| Project Title: | Fountain Wind Project |
| Document Title: | fwp_project_description_2024_update_redline |

Reference: Fountain Wind Project Updated Project Description

Project Description

Figure 5 Typical Overhead Collector Line Pole

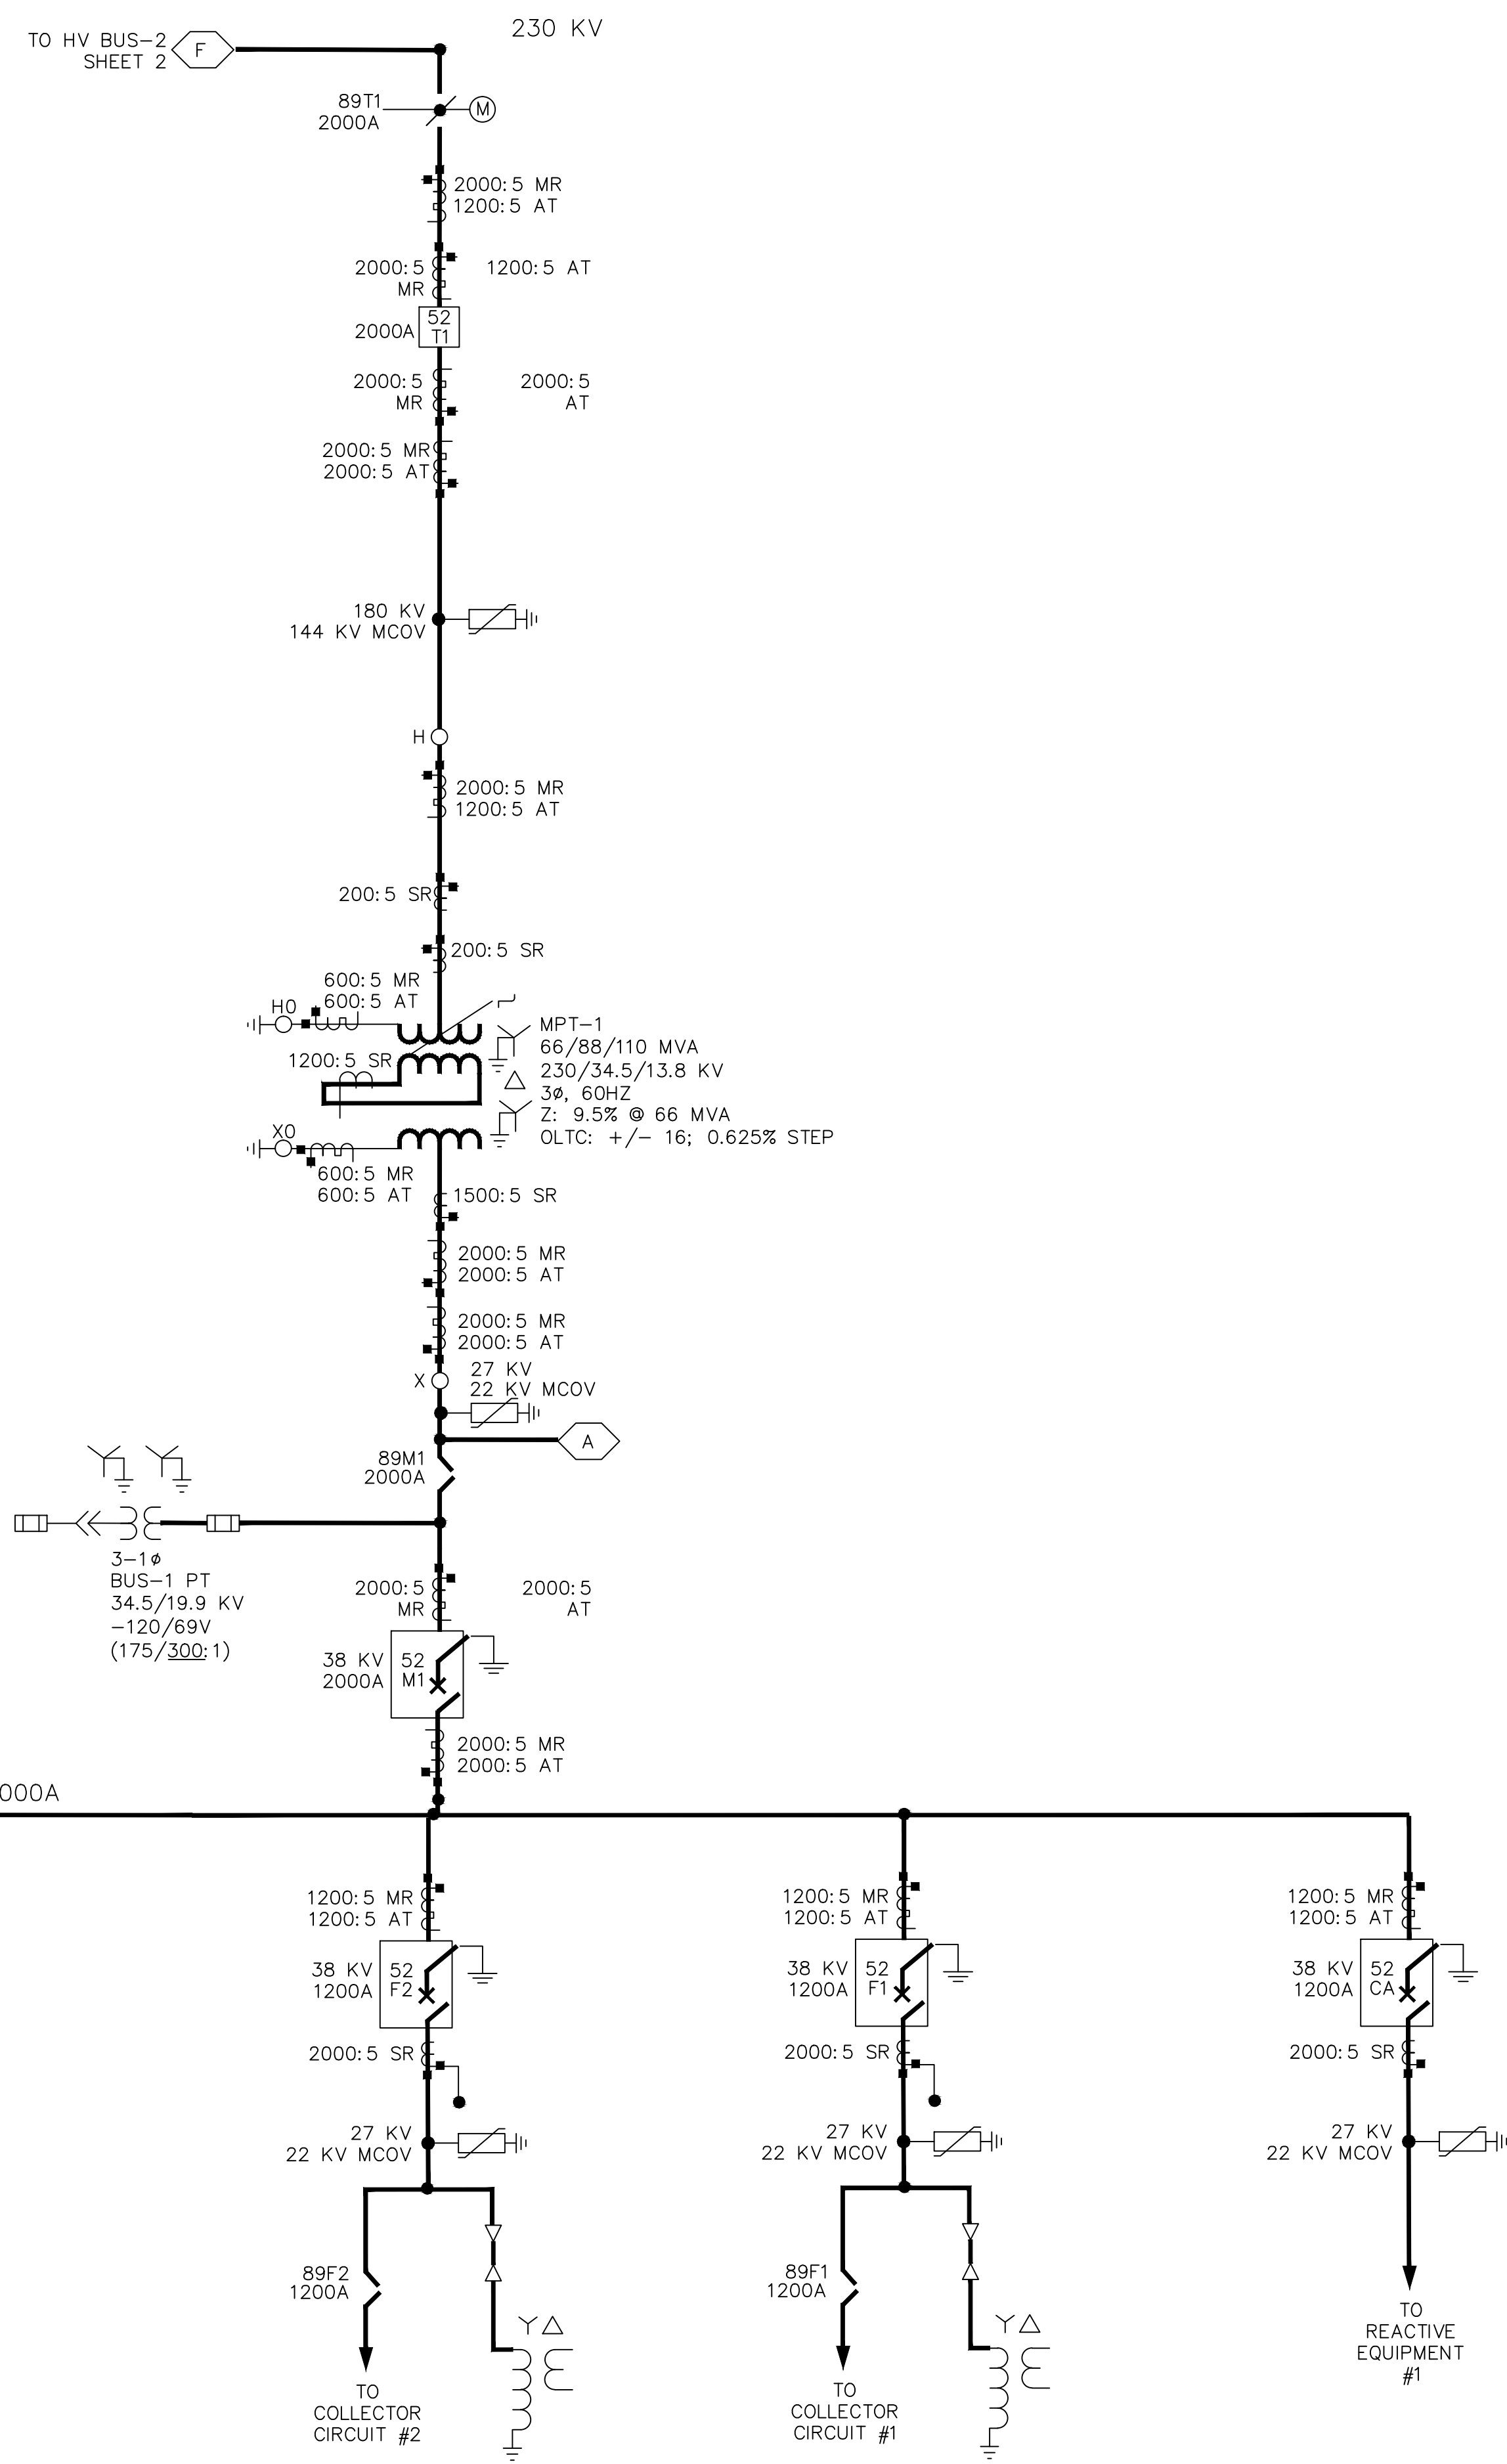
See also Figure 5, which shows conceptual design details of the proposed overhead collector system poles.

The 34.5 kV overhead electrical collector system would be installed on wood poles with a maximum height of 90 feet and wire heights between approximately 20 to 30 feet above the ground depending on the span (Figure 5); however, special circumstances could require greater wire clearances. Installation of the overhead collector line could require a temporary workspace consisting of an approximately 100-foot-wide corridor centered on the
